CITY OF ALBUQUERQUE

RE: 8500 Glendale Ave. NE
Grading and Drainage Plan
Engineer's Stamp Date: 04/25/19
Hydrology File: B20D067

Based upon the information provided in your submittal received 04/25/2019, the Grading & Drainage Plan **is not** approved for Building Permit, Grading Permit, and for action by the DRB on Site Plan for Building Permit. The following comments need to be addressed for approval of the above referenced project:

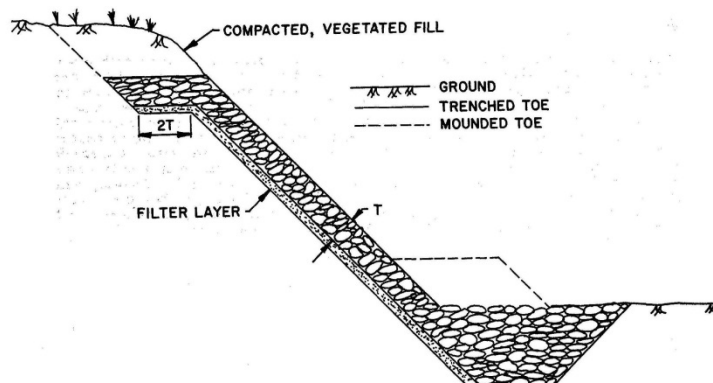
15. Please provide section of the riprap with all required dimensions. See image below. Also please call out the riprap type per City of Albuquerque Specification Section 109 (Riprap Stone). Please use the thickness of 1.2 ft as stated in your calculations.

TITLE: 8500 Glendale Grading & Drainage Plan

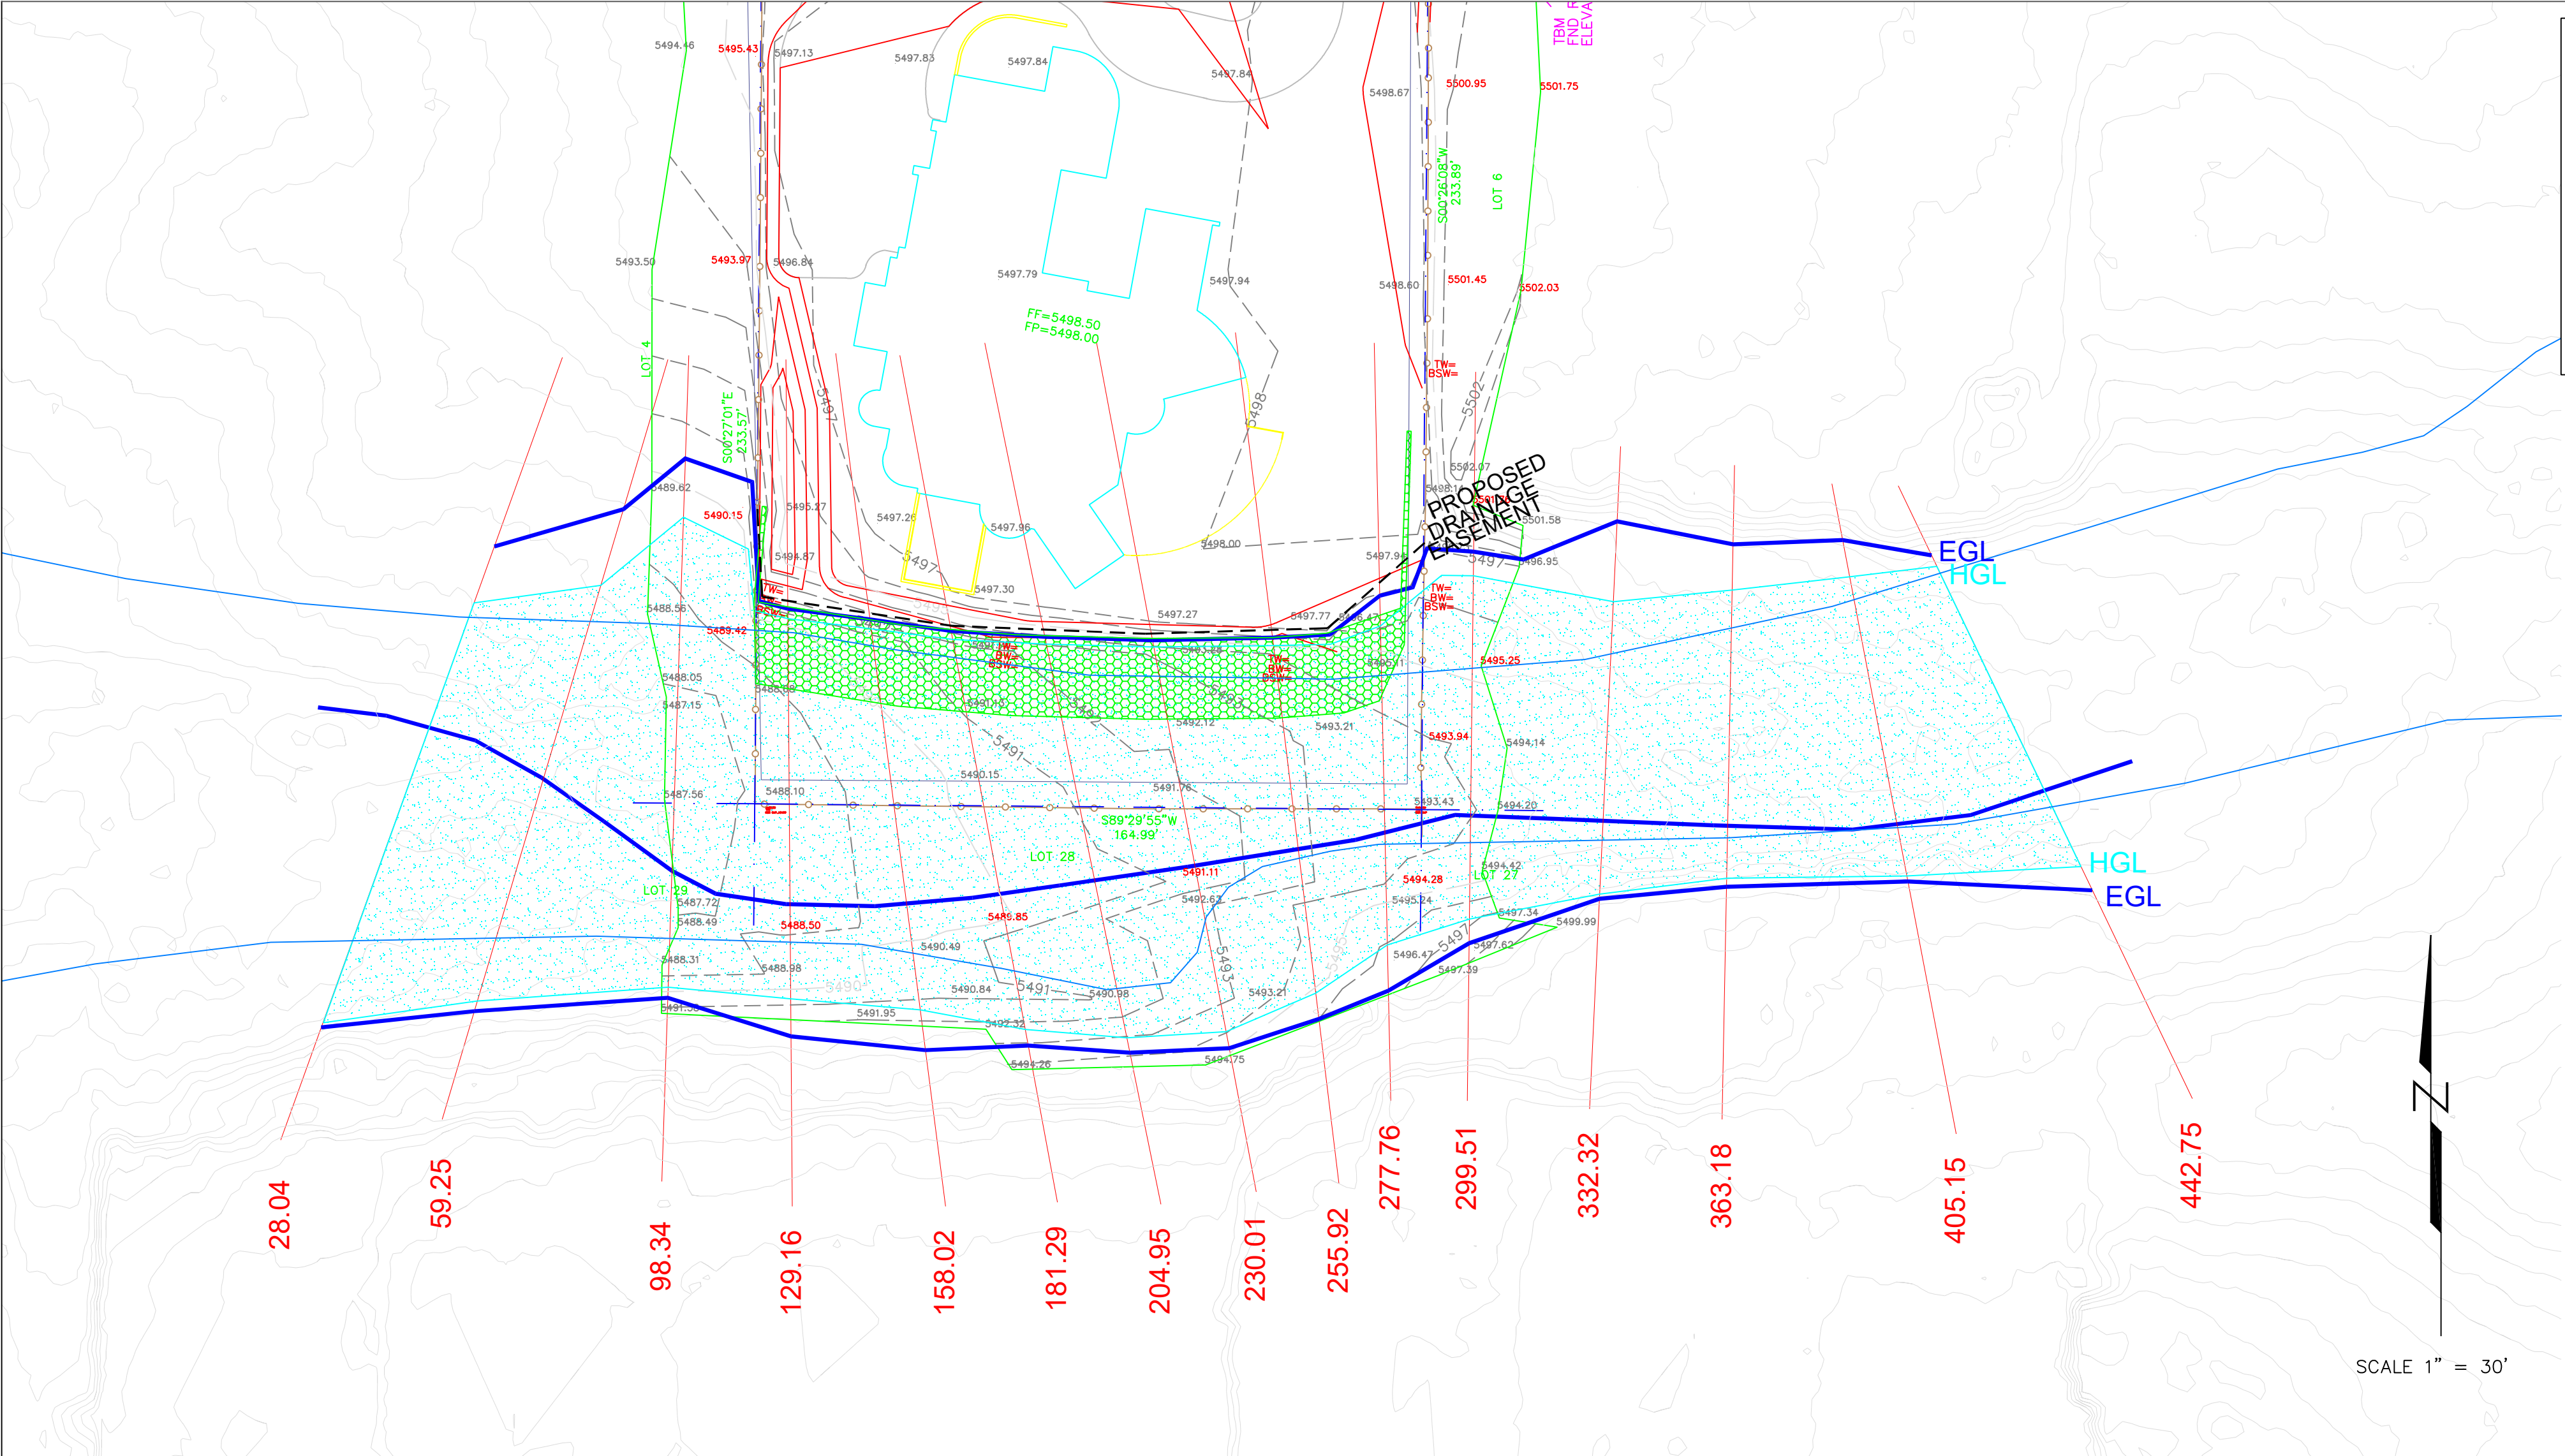
2. Please use the drafting standards outlined in the DPM. Plans need to be black & white with appropriate line weights for existing and proposed items. Color plans are very hard to read.

3. Please also ensure that all linetypes are either labeled or in the Legend.
4. At the northwest corner of the property, there is proposed grating on the adjacent property. A written approval from the adjacent property owner is required prior to Building Permit approval.

5. Per DPM Ch. 22.5.B, grading and construction of retaining walls at or near the property line must demonstrate that the adjacent property is not damaged or its use constrained. Any such encroachment by the wall or grading must be accompanied by written permission of both landowners. Wall footer cannot extend over the property line.

6. Please provide a cross section of the retaining wall. This section should include the distance of the proposed block wall to the property line, the proposed grades on both sides of the wall, and the wall footer. Wall footer cannot extend over the property line.

7. Please provide the top of wall elevation, the proposed grades on both sides of the proposed retaining wall at all important places along the proposed block wall.

8. It seems that storm water quality ponding is being provided. Please note that for single family residence, storm water quality ponding is not required.

9. Please label the R.O.W. (Glendale Ave.).
10. Please label the existing edge of pavement within the R.O.W.
11. Please clarify what is being proposed within the R.O.W. There are multiple lines without any labels. Per the IDO § 6-4(Q), the property owner of the property is responsible for building the adjacent half of Glendale Ave to include curb & gutter, sidewalk, and 84" storm sewer per the North Albuquerque Acer Master Drainage Plan. The plan will have to go to the DRB for approval of the Infrastructure List which will have to financially guaranteed.

12. Please provide a detail section of the scour wall along the East property lines. This section should include the distance of the proposed wall to the property line and should match the depth requirements from the calculations of 9.15 ft scour depth. This scour wall needs to extend to the southern edge of the riprap.

13. Please remove the scour wall along the West property line. This is not needed since the arroyo cannot expand at more than a 3:1 angle.
14. The western edge of the riprap needs to be thickened to prevent erosion. Please add a note.

16. Please provide a profile of the riprap along the channel with the average slope, top elevation, bottom elevation, and toe elevation of the channel.

17. Please provide the digital copy of the HEC-RAS file for our record and review.
18. For the Proposed Drainage Easement shown, please removed the easement line along the western property line. The easement can stop at the property line. The easement along the eastern property line needs to be along the west side of the scour wall to the ESB line and then to the property line.
